Technical Service Bulletin (TSB) Noise From Front End While Driving

REFERENCE:	TSB: 02-005-24 REV. B GROUP: 02 - Front Suspension	Date:	August 3, 2024	REVISION:	02-005-24 REV. A
VEHICLES AFFECTED:	2023 (JT) Jeep Gladiator 2024 (JL) Jeep Wrangler This bulletin applies to vehicles built on or after May 15, 2023 (MDH 0515XX) and on or before June 30, 2023 (MDH 0630XX) equipped with equipped with Front Disconnecting Stabilizer Bar (Sales Code SHG).	MARKET APPLICABILITY:			
		<input checked="" type="checkbox"/> NA		<input checked="" type="checkbox"/> MEA	
		<input checked="" type="checkbox"/> SA		<input checked="" type="checkbox"/> IAP	
		<input type="checkbox"/> EE		<input checked="" type="checkbox"/> CH	
CUSTOMER SYMPTOM:	Customers may experience the following: <ul style="list-style-type: none"> Noise (rattle/thump/clunk noise) coming from the front end of the vehicle. 				
CAUSE:	Manufacturing issue

Fig. 1
Example ASBS Label

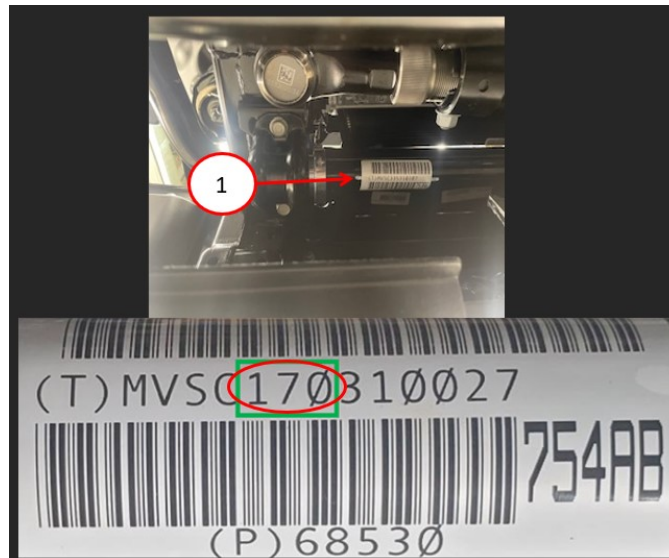
1. Raise and support the vehicle. Refer to the detailed service procedures available in DealerCONNECT/ Service Library under: Service Info> 04 - Vehicle Quick Reference / Hoisting / Standard Procedure.
2. Inspect the Julian date on the ASBS [Fig. 1](#).

3. Is the Julian date 165 or lower?

- YES >>> Replace the ASBS. Refer to the detailed service procedures available in DealerCONNECT/ Service Library under: Service Info>02 - Front Suspension / Front / Stabilizer Bar / Removal and Installation.
- NO >>> This bulletin has been completed, use Inspect LOP (02-20-01-94) to close this active RSU.
